From: Town Clerk
To: Maura Weissleder
Subject: FW: Opposition to the proposed cell tower at 62 Granite Springs Road
Date: Tuesday, March 3, 2026 3:25:37 PM

From: rapappas
Sent: Tuesday, March 3, 2026 3:17 PM
To: Town Clerk <townclerk@yorktownny.gov>; Ed Lachterman <elachterman@yorktownny.gov>; Patrick Murphy <pmurphy@yorktownny.gov>; Sergio Esposito <sesposito@yorktownny.gov>; Susan Siegel <ssiegel@yorktownny.gov>; Ilan Gilbert <igilbert@yorktownny.gov>
Cc: nocelltoweryorktown@yahoo.com
Subject: Opposition to the proposed cell tower at 62 Granite Springs Road

3/3/26
RE: Opposition to the proposed cell tower at 62 Granite Springs Road
Dear Town Board Members,
I write in opposition to the construction of a 130-foot macro cell tower at 62 Granite Springs Road.
The developer has not established that there is a significant gap in cellular service in the area. To the extent there is a gap, the Cityscape report recommendation is that one “small cell” be placed on an existing utility pole. A macro cell tower is not recommended.
Further, the proposed plan would have drastic negative environmental effects. The proposed site is directly adjacent to Stuart’s Fruit Farm - the oldest working f

Figure Y11: Predicted LTE Coverage Northern Yorktown

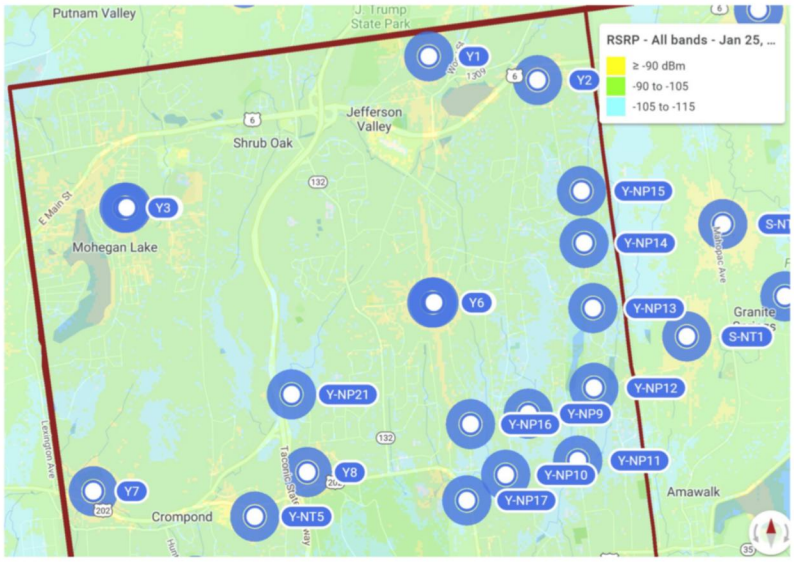
The second reason the applicant's reliance on the Cityscape Report is misplaced is that **the Cityscape Report does not recommend a macro cell tower at this location**. The Yorktown appendix of the Cityscape Report is not on the Town's webpage for this project, although I strongly believe it should be, as it has been repeatedly used to justify the construction of this tower. Page 121 of the Cityscape Report includes the recommendations for the proposed site. The location where the applicant wants to build a macro cell tower is identified in Figure Y11 on page 121 as Site Y-NP12 (Footnote 3). The Cityscape Report states that "ten small wireless facilities are suggested on existing Cons Ed utility poles or new 50' utility poles in the same areas as Sites Y-NP9, Y-NP10, Y-NP11, YNP12, Y-NP13, Y-NP14, Y-NP15, Y-NP16, Y-NP17 and Y-NP21." The Cityscape Report goes on to state that "small wireless Sites Y-NP9, Y-NP10, Y-NP11, YNP12, Y-NP16 and Y-NP17 are needed to provide capacity densification east of Crompond Road because the significant number of people residing per square mile in those census blocks." Further, the Cityscape Report recommends only one macro cell facility in the northern part of town, to be placed in the vicinity of the Taconic State Parkway and Crompond Road, on the site represented as potential Site Y-NT5 in Figure Y11 on Page 121.

3- If that is unclear from Figure Y11 on page 121 because blue shading is used, you can verify this by looking at any of the other figures within the Cityscape Plan. For example, you can compare Figure Y1 on Page 5 to Figure Y11 on page 121 and clearly see that the site of the proposed tower is represented by Site Y-NP12 on Page 121.
